Ordinary Council Meeting

MUSWELLBROOK SHIRE COUNCIL

8.1.1. Draft Development Control Plan - Ironbark Ridge Extension

Objection and Comments on DRAFT DEVELOPMENT CONTROL PLAN – Section 30 Ironbark Ridge Extension. Lot 101 DP 1170190, LOT 103 DP 1170190

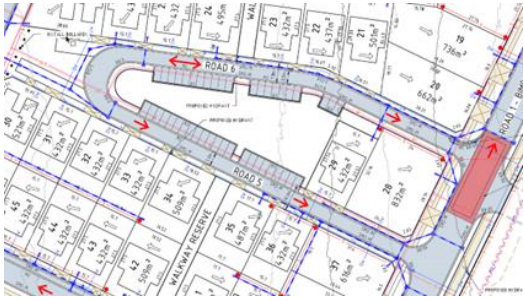
<p>Private access road to some dual occupancies is too narrow</p> <p>The multi-dwelling housing located on proposed Lot S3 is proposed to be accessed via an internal access driveway. While the internal access is shown on design and civil plans alongside proposed new Council Roads all should be mindful that this internal access is not proposed as a public/Council Road, but rather is a private site access (internal to the proposed Lot S3 – on which 30 of the multi-dwelling house units is proposed).</p> <p>The internal private access can be seen as Road 5 & 6 in the image below.</p>	<p>The one-way access is not a public road but a private access driveway. The one-way access would have a width of 5m.</p> <p>The standard lane width for urban roads (public roads) under AUSPEC is 3.5m. While the proposed access remains a private access it is relevant to note that it comfortably exceeds the 3.5m lane width minimum that would have been applicable for a one-way public road.</p> <p>Turning circles provided confirm that there is sufficient turning capacity for a 12.5m long vehicle to navigate in a single motion. Typical local service vehicles (e.g. waste trucks) are 9.1m in length. NSW RFS General fire appliance vehicles have a standard length of 10m. Standard NSW ambulance vehicle dimensions available</p>

Issue context	Planning Comment
 <p>The road has been put forward as a one-way road. The key reason for the one-way arrangement is to mitigate the potential for conflict between the road intersections with Bimbadeen Road – which are separated by approximately 28m.</p>	<p>online indicate their largest vehicle length is 7.3m.</p> <p>Each of these vehicle types could navigate the proposed private road.</p> <p>Council Officers are satisfied that the roads inclusion as a one-way private access is appropriate and that there is no issue with the access dimensions proposed.</p>
<p>Ironbark Road/Rutherford Road intersection</p>	<p>A traffic Impact Assessment has been prepared in relation to the proposed development by a qualified traffic engineer. The development and this document have been reviewed by Council's Engineers.</p> <p>Council Engineers have not raised any concern with the potential impact of the development on the Rutherford Road/Ironbark Road intersection. No upgrade or alteration to this intersection has been recommended by Council technical road officers.</p>

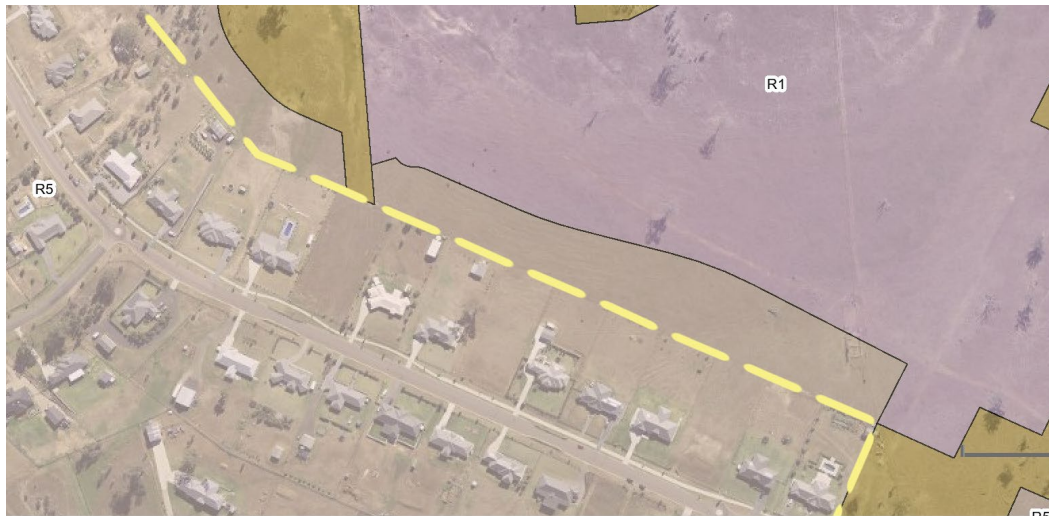
- Doubt about population growth and desirability of Muswellbrook for young people as a place to live so properties won't sell.

This is not a reason not to approve a development and is our risk as developers. These comments are not supportive of building the town of Muswellbrook and I propose that we all need to work together to change this perception.

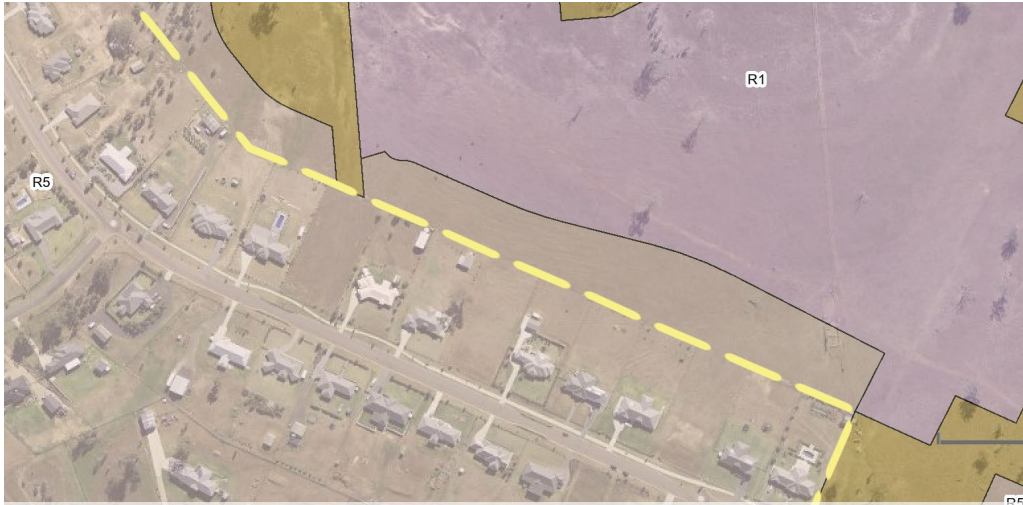
- Real estate at the time of selling Stage 2 indicated that the land was “Convenient with Rural Living” so rural not residential.

The lots on Ironbark road are R5 rural residential. The lots adjoining the Ironbark road as seen below are rural residential as well so this is not inconsistent with what the real estate agent advised.
